ENGINE - INCORPORATE REPLACEMENT VARIABLE INLET GUIDE VANE BRACKET - CATEGORY CODE 4 -  
MOD.ENG-72-0019

(2) Engine: V2500-A1 Engine, Serial No's.V0014 through V0061, V0063, V0065  
and V0066

V2500-ENG-72-0019

Change of the bracket  
Fig.1

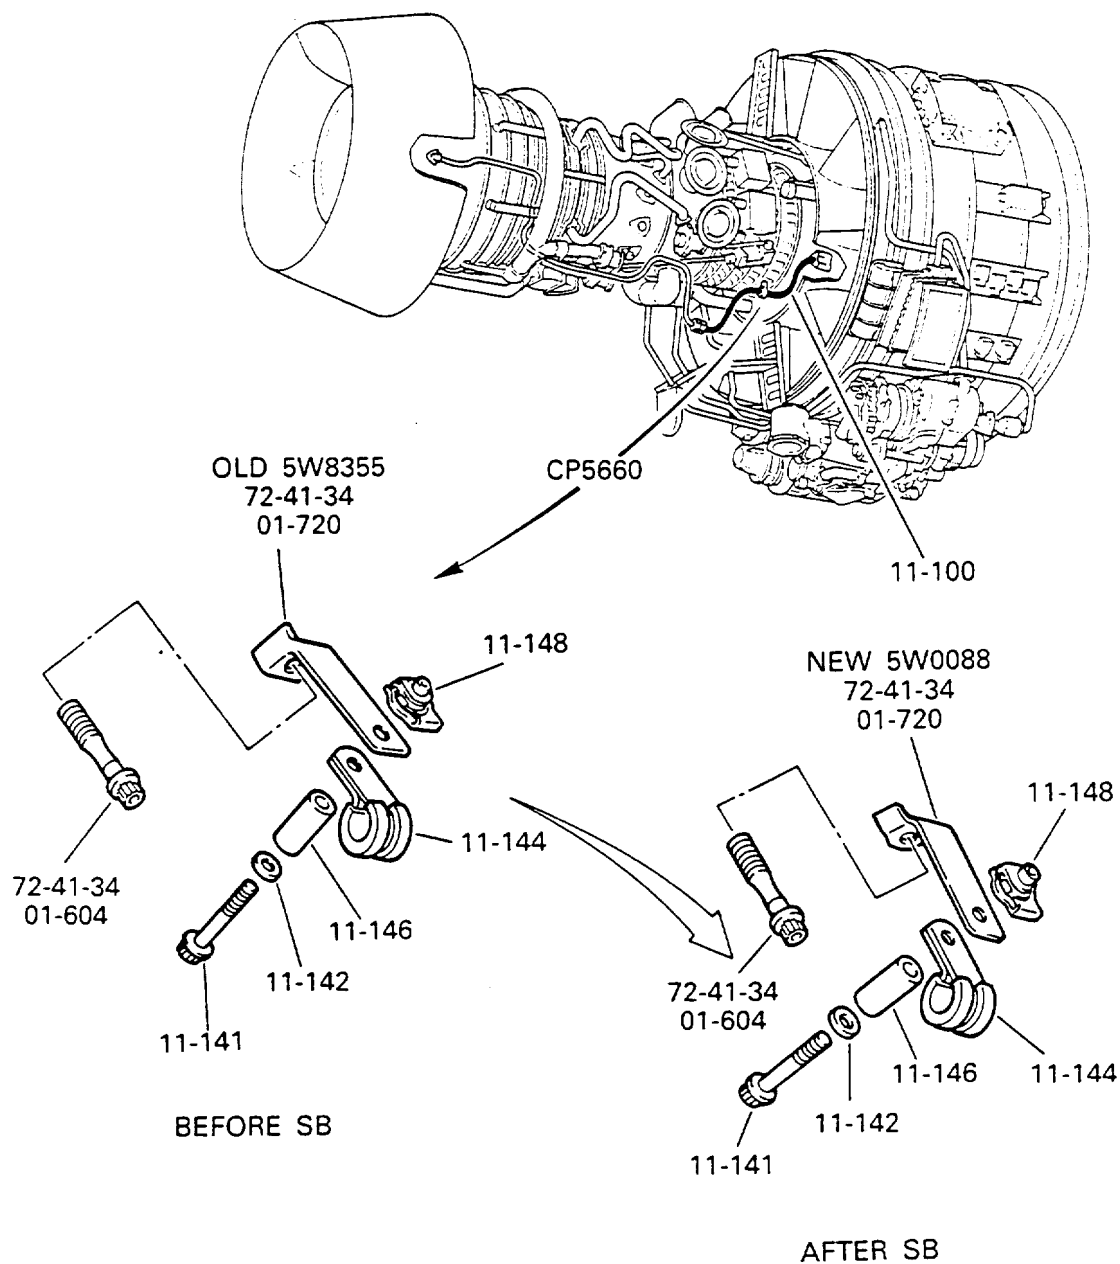
- (1) Remove PN 5W8355, Bracket (72-41-34-01-720), Figure 1 and 2
- (a) Remove bolt (11-141), washer (11-142) and spacer (11-146) at the clipping point 5660.
  - (b) Let clip (11-144) stay on tube (11-100).
  - (c) Remove bolt (72-41-34-01-604) from Shaft, Assy.
  - (d) Remove PN 5W8355, Bracket (72-41-34-01-720) from the engine.
  - (e) Remove nut (11-148) from the Bracket (72-41-34-01-720), Figure 2.

- (1) Install PN 5W0088, Bracket (72-41-34-01-720), Figure 1 and 3
- (a) Put nut(11-148) on PN 5W0088, Bracket (72-41-34-01-720), Figure 3.
  - (b) Install PN 5W0088, Bracket (72-41-34-01-720) in position on the engine.
  - (c) Tighten bolt (72-41-34-01-604) to 150 to 170 lbfin (16.94 to 19.21 Nm).
  - (d) Install bolt (11-141), washer (11-142) and spacer (11-146) at the clipping point 5660.
  - (e) Tighten bolt (11-141) to 32 to 36 lbfin (3.61 to 4.07 Nm).

New Bracket is incorporated to improve the installation.

Removal of clip and nut assembly  
Fig.2

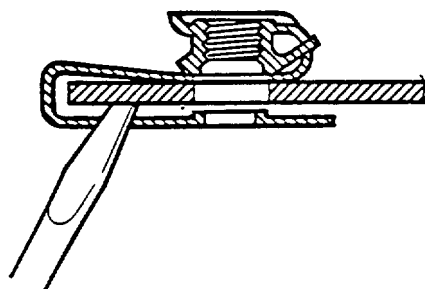
Put the tapered thin end of a suitable lever into the engaging bracket and the spigot side of the clip. Turn the lever to lift the spigot clear of its socket. The clip and nut assembly can then be removed from the engaging bracket.

Installation of clip and nut assembly  
Fig.3

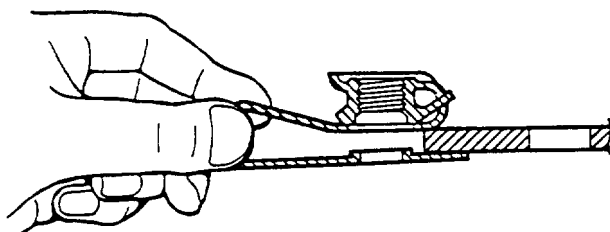
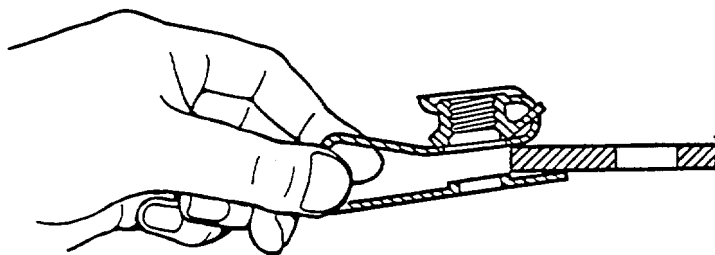
(1) Push the mouth of the clip against the engaging bracket as shown.

(2) Push in the rear of the clip sufficiently to ensure that the locating spigot will clear the edge of the engaging bracket.

(3) Push the clip forward so that grip is moved to the spigot face.

(4) Move the clip along the engaging bracket until the locating spigot correctly engages in its socket.

(5) When the locking torque of the nut and bolt installation falls below the value of 2 lbf in. (0,226 Nm) the entire clip and nut assembly is to be discarded and a new one used for replacement.
